Knocking Noise From Fuel Tank Area

Service Category Engine/Hybrid System

Section Fuel System

YEAR(S)	MODEL(S)	ADDITIONAL INFORMATION
2017 - 2019	Highlander

Figure 1. Without Pulsation Damper Valve Assembly Installed

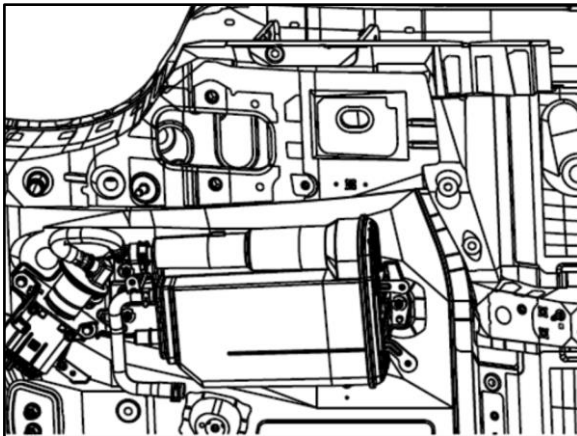
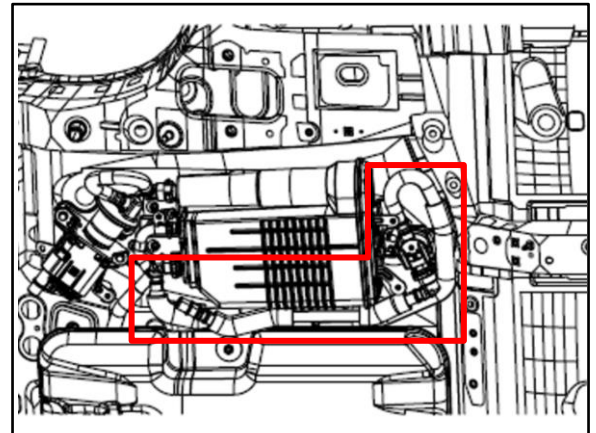
2. Confirm if the vehicle has the NEW pulsation damper valve assembly installed.

The NEW part can be identified by the addition of a bracket and valve assembly attached to the charcoal canister.

Does the vehicle have the NEW pulsation damper valve assembly installed?

- **YES** — This bulletin does NOT apply. Continue diagnosis using the applicable Repair Manual.
- **NO** — Continue to step 3.

Figure 3.

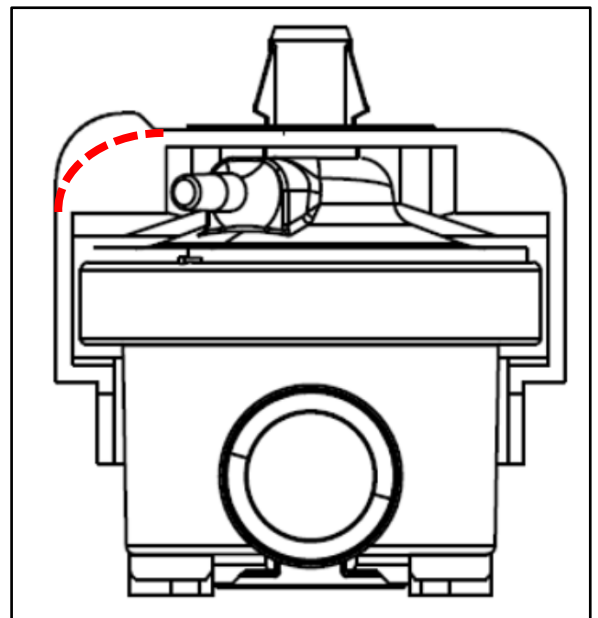
- 2017 – 2019 Highlander:
Engine/Hybrid System – Emission Control – [“2GR-FKS Emission Control: Canister: Removal”](#)
 - D. To provide adequate clearance to the NEW bracket, trim the NEW pulsation damper valve as shown.

Figure 4.

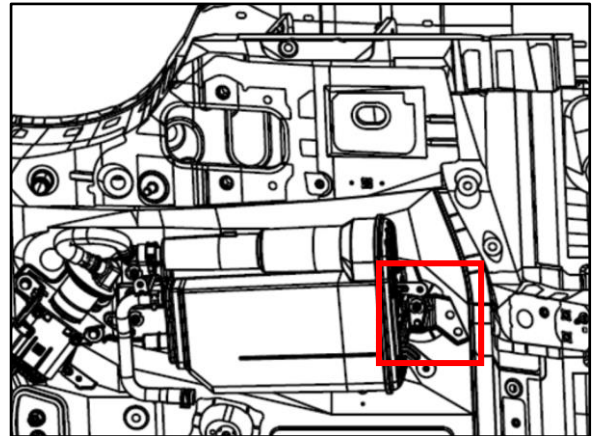
F. Install the NEW bracket to the charcoal canister.

- (1) Remove the nut from the front of the charcoal canister.
- (2) Install the bracket on the stud.
- (3) Tighten the nut and valve assembly plate into place.

Torque: 5.5 N*m (56 kgf*cm, 49 in*lbf)

Figure 5.

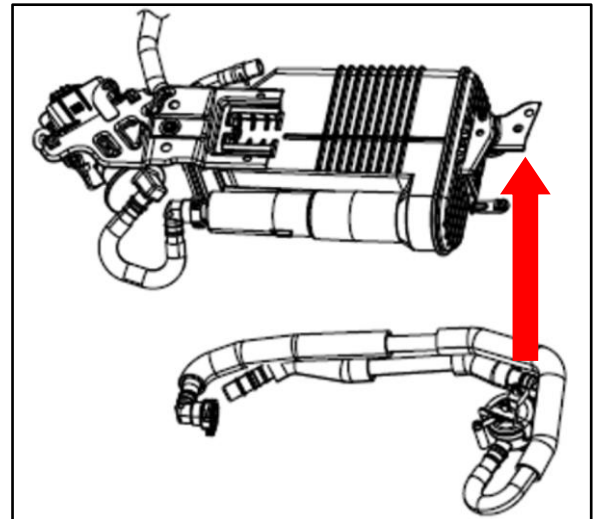
G. Install the NEW pulsation damper valve assembly onto the NEW bracket. Push both retaining clips of valve assembly through the two holes on the bracket.

Figure 6.

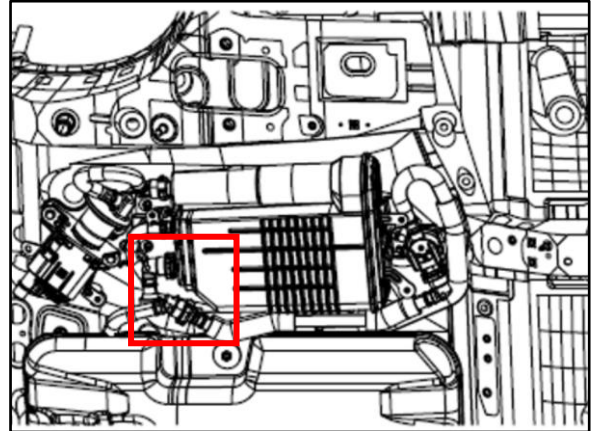
- H. Connect the NEW pulsation damper valve assembly to the charcoal canister.

Figure 7.

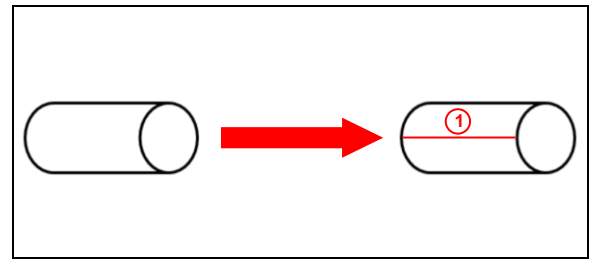
- I. Cut the two reflect sleeves as shown.

Figure 8.

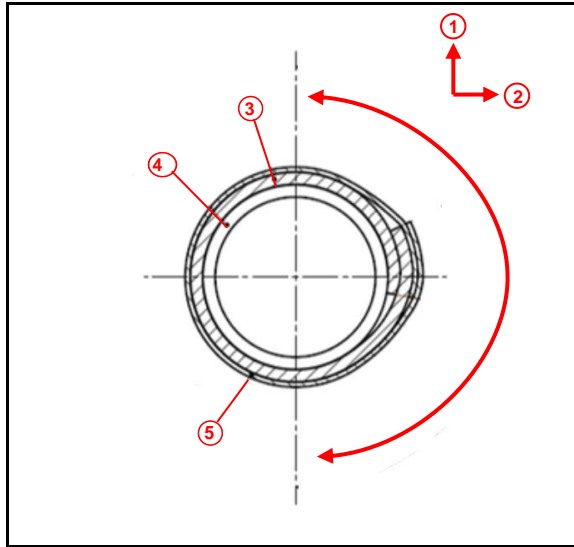
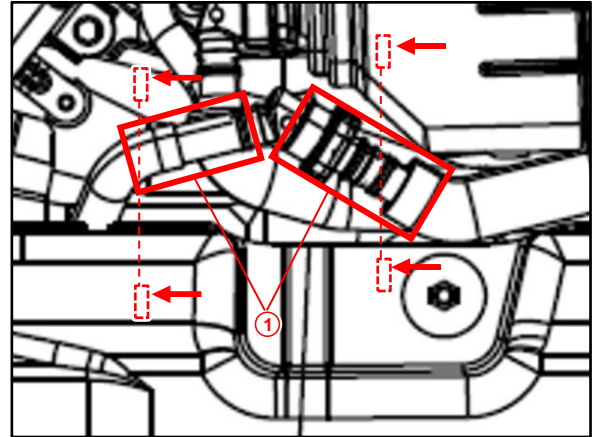
- J. Wrap the two reflect sleeves around each of the vent tube connections and tape them into place as shown in Figures 8 and 9.

Figure 10. Zip-Tie Locations

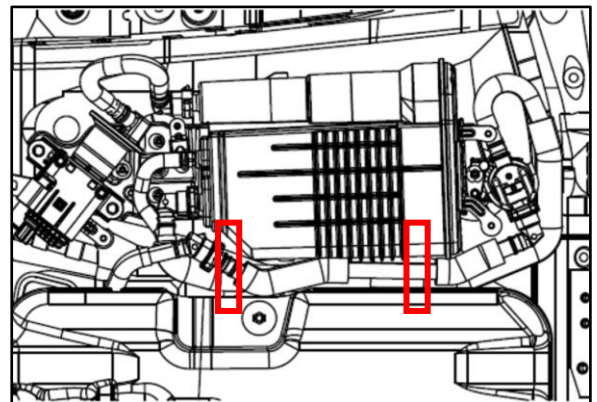
- K. Using the zip ties supplied, tie the NEW pulsation damper valve assembly to the purge line as shown by doubling the zip ties together for each location.

Double or connect the zip ties to provide adequate length to secure assembly.
